**LYNWOOD QUARRY
EXTRACTION AREA
MODIFICATION
(MOD 4)**

Response to Submissions

February 2016

Prepared by
Umwelt (Australia) Pty Limited
on behalf of
Holcim (Australia) Pty Limited

FIGURE 2.5

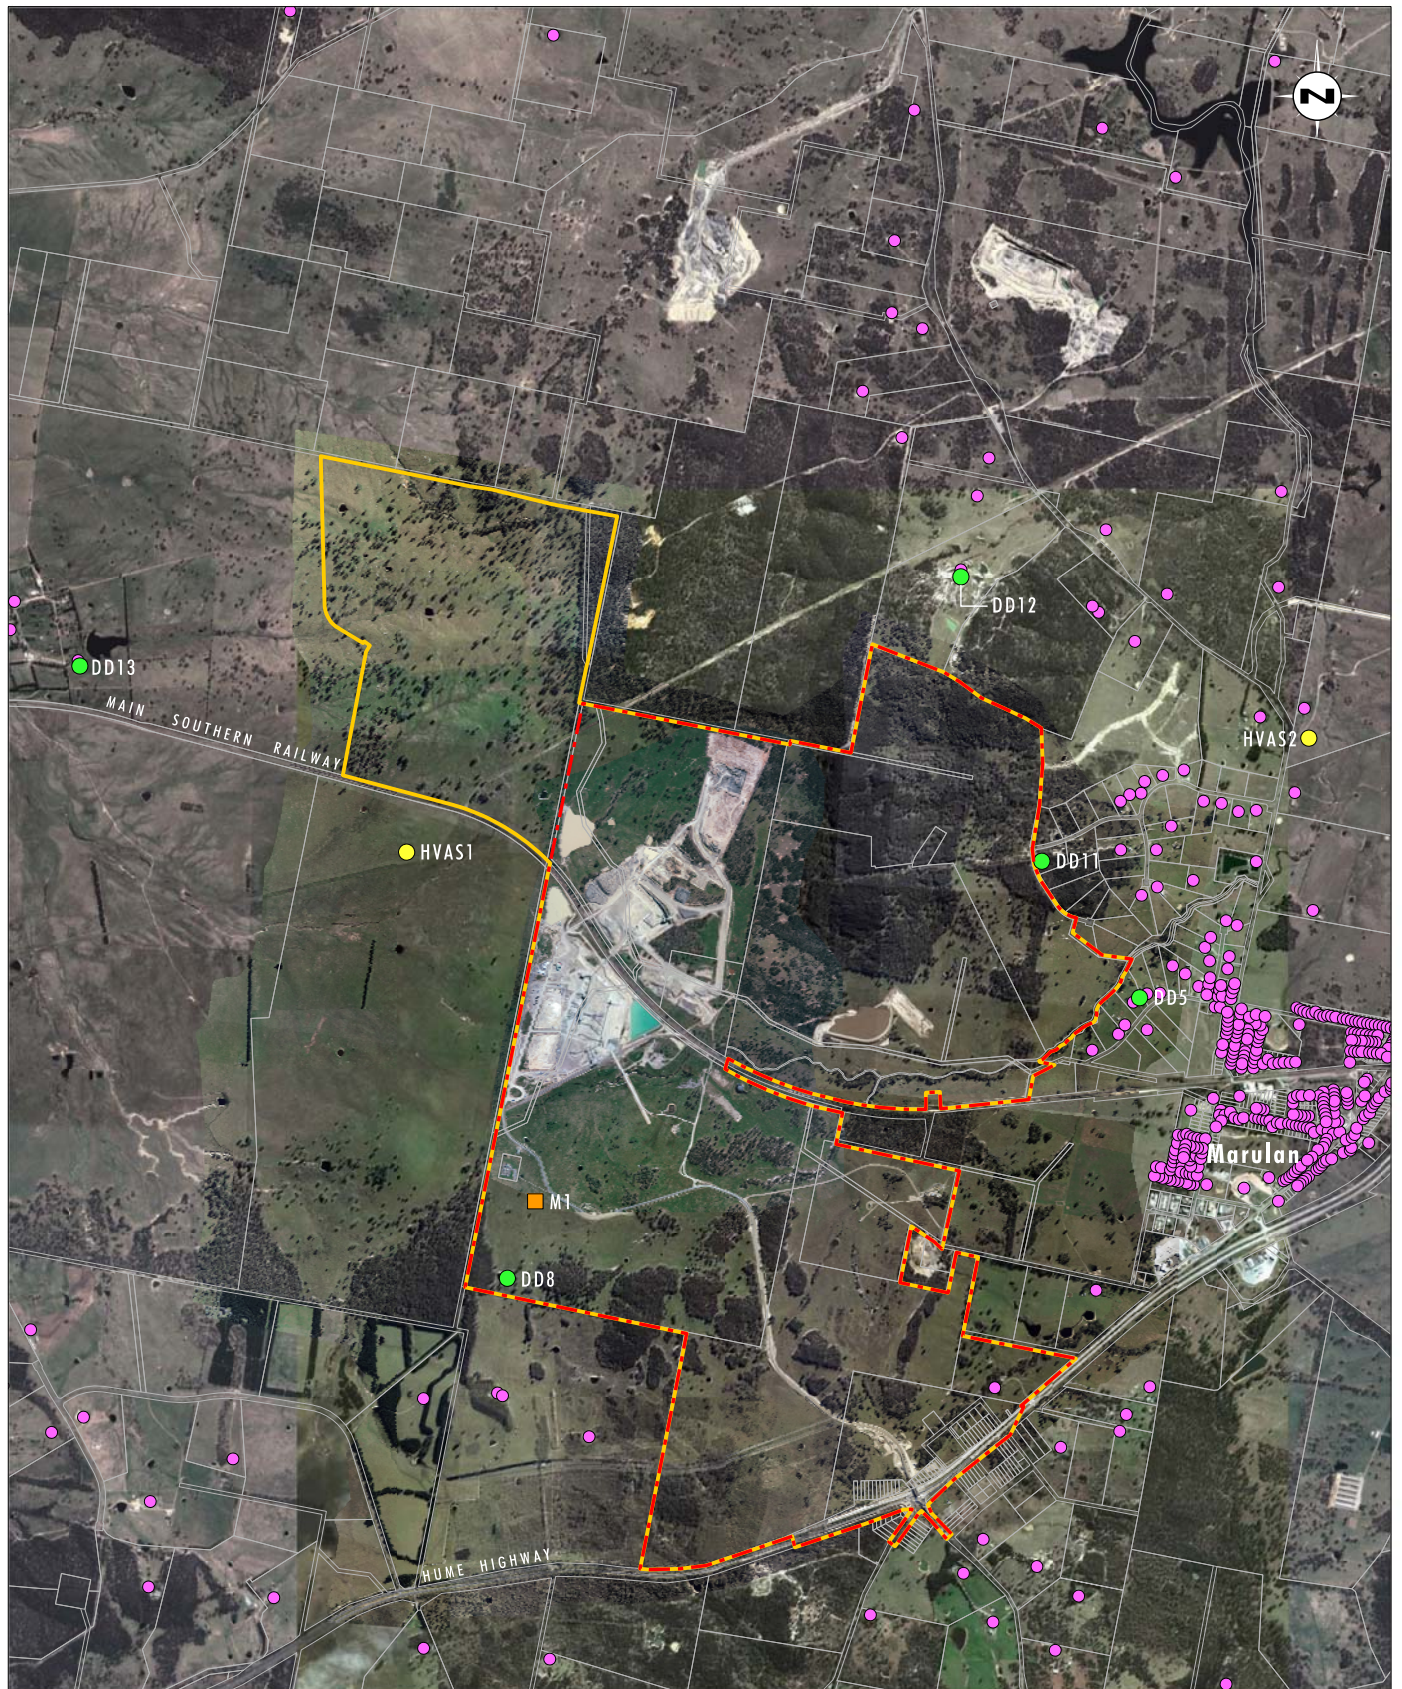
Ideally a HVAS or at least a dust deposition gauge should be installed at a suitable location to the north-east of the granite pit extension area following any modification of the Project Approval, given that prevailing winds in the area are generally from the west (winter and spring).

Holcim Australia has undertaken a further review of the existing dust monitoring network in response to the EPA's comments and in preparation of an application to vary the EPL for the site and proposes changes to the existing monitoring network to address the EPA's comments. Subject to the agreement of the relevant landholders, this will include the installation of new dust deposition gauges to the west and northeast of the Granite Pit. The proposed, revised dust deposition monitoring locations are shown on **Figure 2.5**.

Holcim Australia will also investigate the potential relocation of an existing high volume air sampler to the west of the quarry to the nearest residence to the Granite Pit (i.e. to the west) in consultation with the land owner. Should a change in location of the high volume air sampler be proposed as an outcome of these investigations, Holcim Australia will address this issue in the EPL variation and the updated monitoring programs.
